Staff Report

To: BOZAR
From: Kaitlyn Archambault, Planner I and Jessie Earley, Town Planner III
Meeting Date: DRC, February 9, 2026
RE: 322 Maroon Avenue, Secondary Review

PROJECT TITLE: Robert Harper (322 Maroon Avenue)

SUMMARY: Consideration of the application of **Robert Harper** to rehabilitate and site an addition to the contributing historic building, rehabilitate existing historic accessory building and site a new accessory dwelling to be located at 322 Maroon Avenue, Tract 3, Block 22 Minor Subdivision, According to the Plat thereof Recorded September 29, 2004 Under Reception No. 546671 in the R1C zone.

02/09/2026 DRC Site Plan

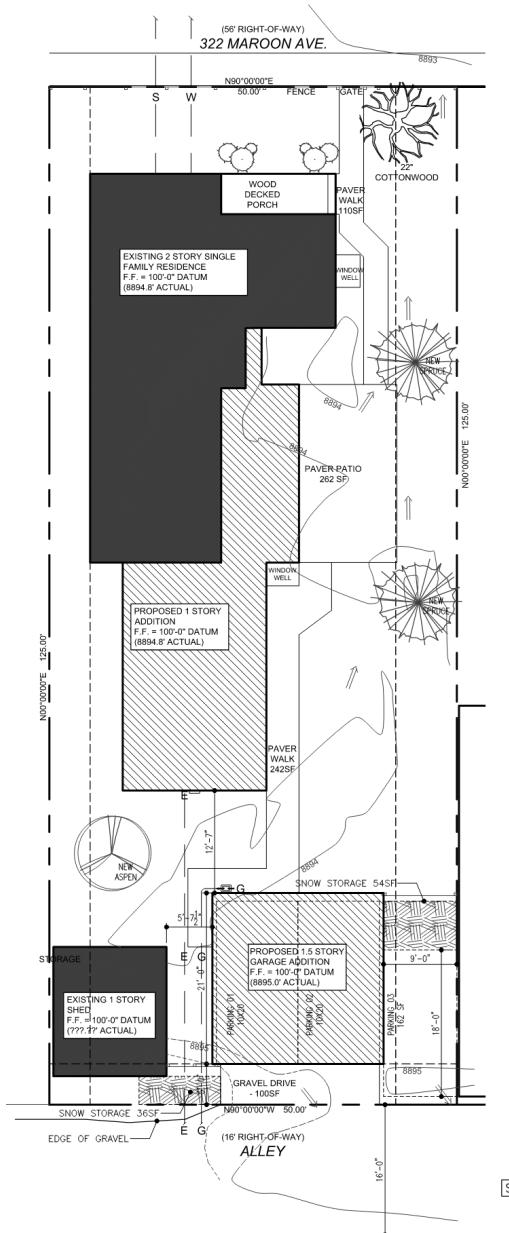
2.8 Drainage	<p>Drainage arrows are shown on the east, but it must be clarified to ensure that this doesn't negatively impact the neighbor. A note has been included on the site plan to say "Water shall not be redirected to drain onto adjoining private property."</p> <p>Topography grade elevations will be required prior to permitting to show the interface with the alley pertaining to drainage.</p>	8/18 DRC: Add information to plans. This has been added to the site plan.
Easements	N/A

2.16 e Pervious materials	<p>There are minimal walkways, driveways or patios noted on the site currently.</p> <p>There is a parking spot noted on the southeast corner. Substrate must be called out.</p> <p>There is a walkway and patio noted as pavers.</p> <p>There is a gravel drive (98.5 sf) on the south side of the proposed ADU.</p>	<p>8/18 DRC: Add information to plans. This has been added to the site plan.</p> <p>11/3 DRC: Applicant proposes concrete paver patio and walkway. Need to call out on site plan.</p>

(2.37-2.40)/ 16-17-40 Exterior Lighting	Down shielded lighting is not noted on the elevations.	<p>8/18 DRC: Add information to plans.</p> <p>11/3 DRC: Add information to plans</p>
Solar	NA	NA
Utilities	<p>Existing and proposed utilities have not been noted.</p> <p>Electric line will be required to be undergrounded per code.</p> <p>Rights of way must be shown to scale on the site plan.</p>	<p>8/18 DRC: Add information to plans.</p> <p>11/3 DRC: Add information to plans.</p>

- Photo provided from 1960's of the front façade, a side view of the front façade from the 1890's and a section from the book "The Spaghetti Gang".
- Small updates to site plan
 - Materials for hardscape called out.
- Step down proposed from existing historic gable module perpendicular to the street (11").
- Large picture window to change to two wood double hung windows.
- Door shown on west elevation of ADU
-

11/18/2025 BOZAR proposal for east/demolition

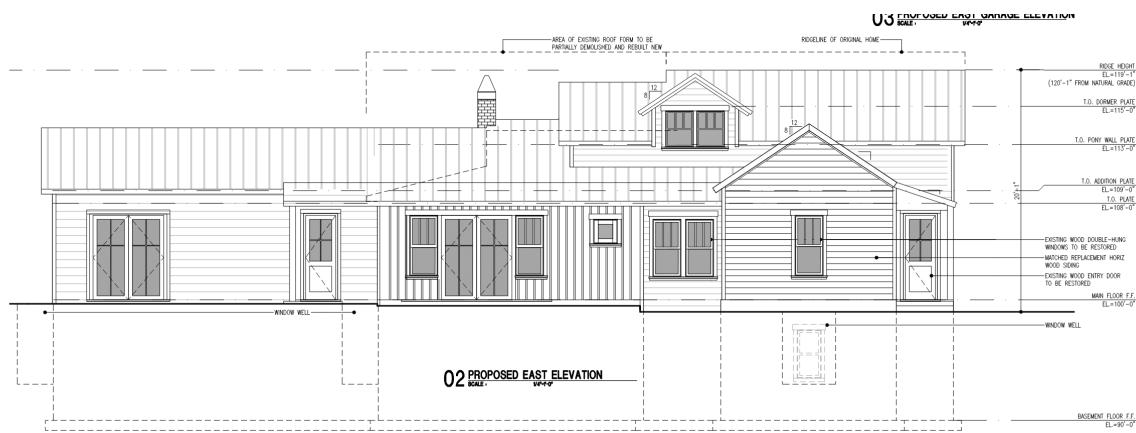
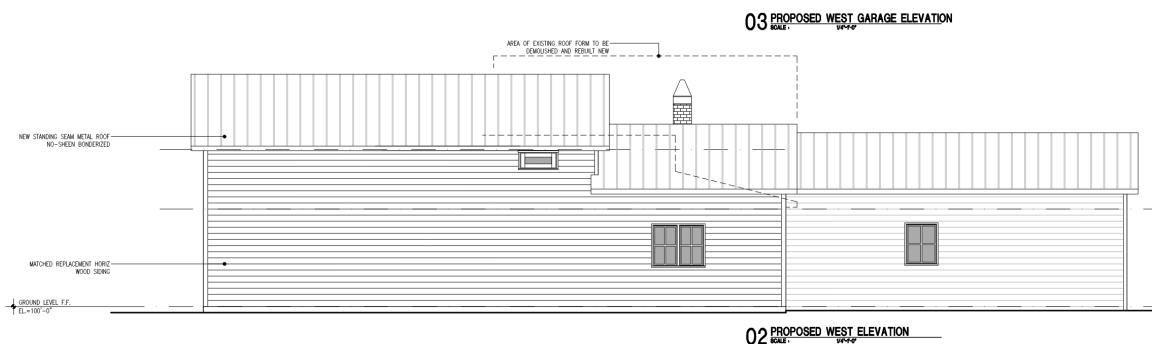
b. Sec. 16-14-190: Demolition of portions of the building: Ordinance No. 34, Series 2019 passed in October of 2019. The ordinance allows for the demolition of up to twenty-five percent (25%) of non-historic residential buildings. This building is a contributing historic structure. The proposal would be for the roof to be removed for the existing hipped portion in the rear. There are discussions below regarding the addition itself regarding this proposed demolition. A plan demonstrating the proposed areas for demolition have been provided, as seen below. This illustrates that the hipped module roof and a portion of the existing gable roof module will be removed to accommodate the new higher addition. Also the chimney will be removed off the front elevation. These proposals for demolition are therefore exempt from the requirements of 16-14-190.

2/9/2025 DRC revised proposal for east/demolition

11/18/2025 BOZAR proposal for west/demolition

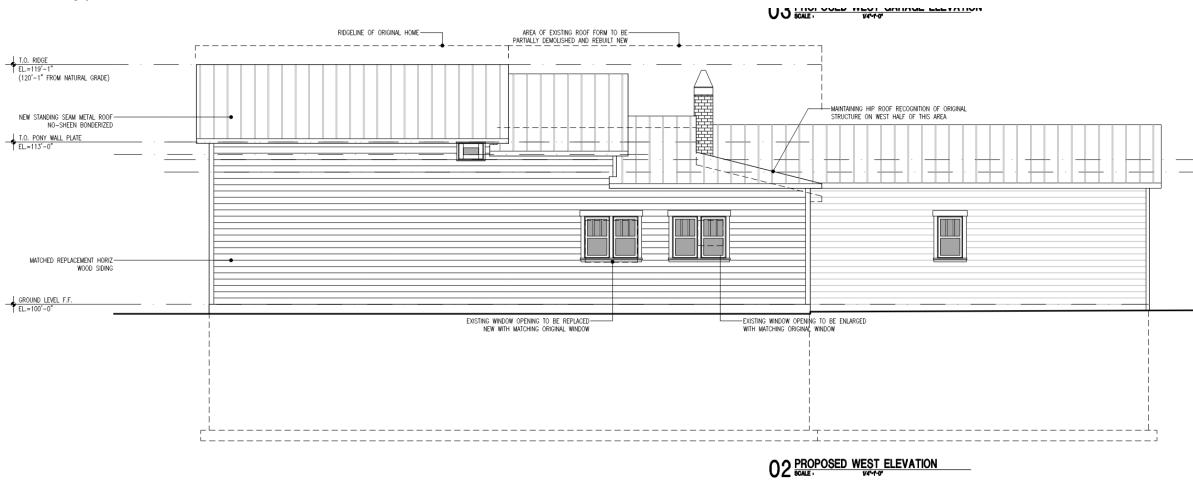
- ADU railing must be wood
- Window on west elevation of ADU in floor plan but not shown in elevations. This will be updated.
- The existing two pack of windows on the west was asked to remain, if historic. If the windows are not historic, the windows could be new but must be in the same opening.
- The horizontal window on the west is supported as it exists, but GL doesn't support increasing the size.
- Floor to ceiling windows on the east were not supported.
- Discussion regarding chimney and window on the north elevation.
- Concerns regarding the proposed addition being the same height as the existing historic home.

o. Accessory dwelling mass/scale/form and placement: Refer to GL 4.84-4.88. The new accessory dwelling is a simple 8:12 gable structure. The building proposes a 20' height.

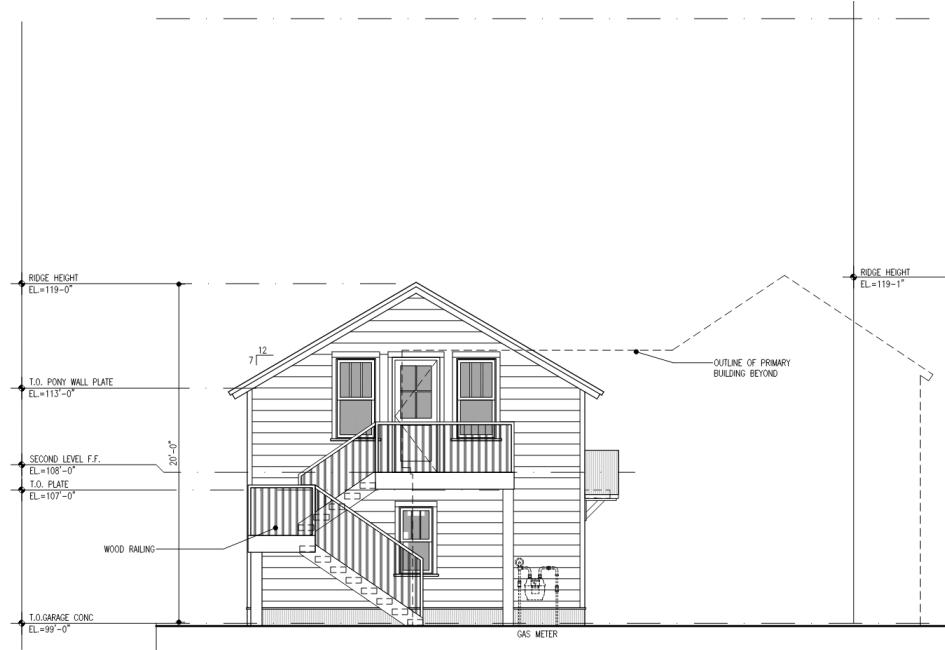
GL	Staff Analysis	DRC Recommendation
4.84 Smaller in size	This building scale appears large in relation to the existing historic structure. The height has been reduced to match that of the existing historic primary building.	Support
4.85 Rear of the site	The building is located on the rear of the lot. Support.	Support
4.86 Vary appearance	This accessory building is simple	Support

GL	Staff Analysis	DRC Recommendation
4.53; 4.89 AB fenestration	The GL (4.88 b) ask for a greater solid to void ratio than the primary building. There are only two windows on the south elevation. There is a two pack on the first floor and two single windows on the second floor.	Support
4.54 Vertical emphasis	Windows are noted as three over one double hung windows.	Support
4.56 Window material	Windows material are noted as aluminum clad, which is supported by the GL.	Support
4.59 Trim	2"x4" trim is shown on the plans. Support.	Support
